SHEET INDEX . SHEET DESCRIPTION COVER SHEET NOTES (GENERAL, GRADING, EROSION CONTROL) TYPICAL SECTIONS 5 FINAL GRADING AND EROSION CONTROL PLAN 3 OFFSITE POND C1, C3, AND E2 GRADING PLAN	EPARED FOR: EPARED FOR: LORSON, LLC 212 N. WAHSATCH AVE, SUITE OLORADO SPRINGS, COLORADO (719) 635-3200 CONTACT: JEFF MARK
ER'S STATEMENT	RANCH EAST VG NO. 4 BLVDLAMPREY DR SPRINGS, COLORADO
R/DEVELOPER HAVE READ AND WILL COMPLY WITH THE TS OF THE GRADING AND EROSION CONTROL PLAN. AME LORSON, LLC Glolg	NOSUDI NOSUDI ON DRAWN: RLS DESIGNED: RLS CHECKED: RLS
EFF MARK DATE MANAGER	Z
212 N. WAHSATCH AVE. SUITE 301 COLORADO SPRINGS. CO 80903 COLORADO SPRINGS. CO 80903	LORSON RANCH EAST FIL. NO. 4 GRADING & EROSION CONTROL PL COVER SHEET
R'S APPROVAL NG AND EROSION CONTROL PLAN WAS PREPARED UNDER MY DIRECTION VISION AND IS CORRECT TO THE BEST OF MY KNOWLEDGE AND BELIEF. HAS BEEN PREPARED ACCORDING TO THE CRITERIA ESTABLISHED BY Y FOR GRADING AND EROSION CONTROL PLANS. I ACCEPT LITY FOR ANY NEGLIGENT ACTS, ERRORS, OR OMISSIONS ON MY PART NG THIS PLAN SCHINDLER, P.E. # 33997 DN BEHALF OF CORE ENGINEERING GROUP	DATE: JUNE 1, 2019 PROJECT NO. 100.048 SHEET NUMBER CO.1 TOTAL SHEETS: 13

Markup Summary 7-23-20

STANDARD NOTES FOR EL PASO COUNTY GRADING AND EROSION CONTROL PLANS

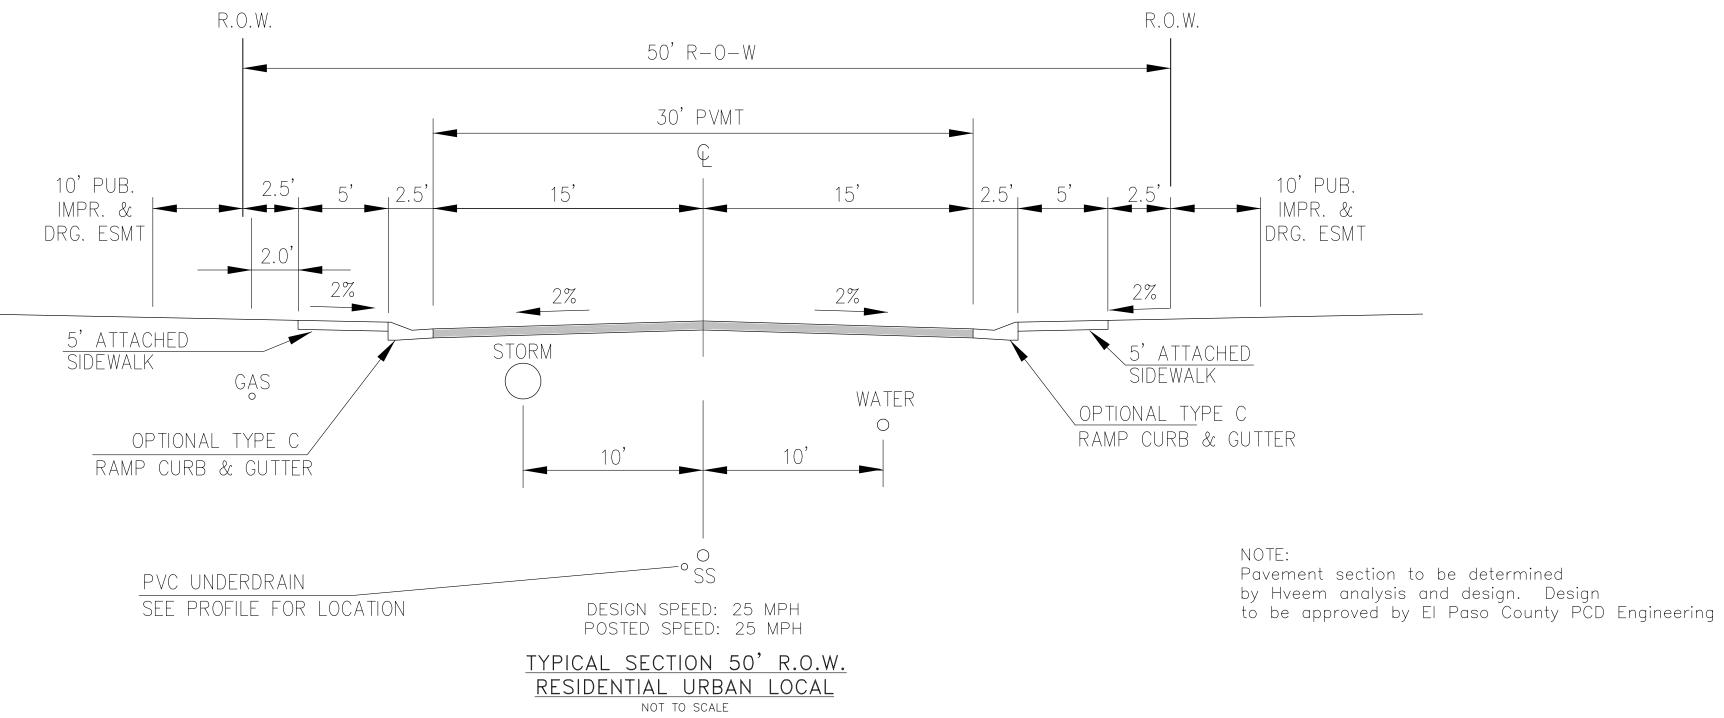
> Provide the 7/2/2019 grading and erosion control notes. See comment letter and e-mail of 7/23/2019.
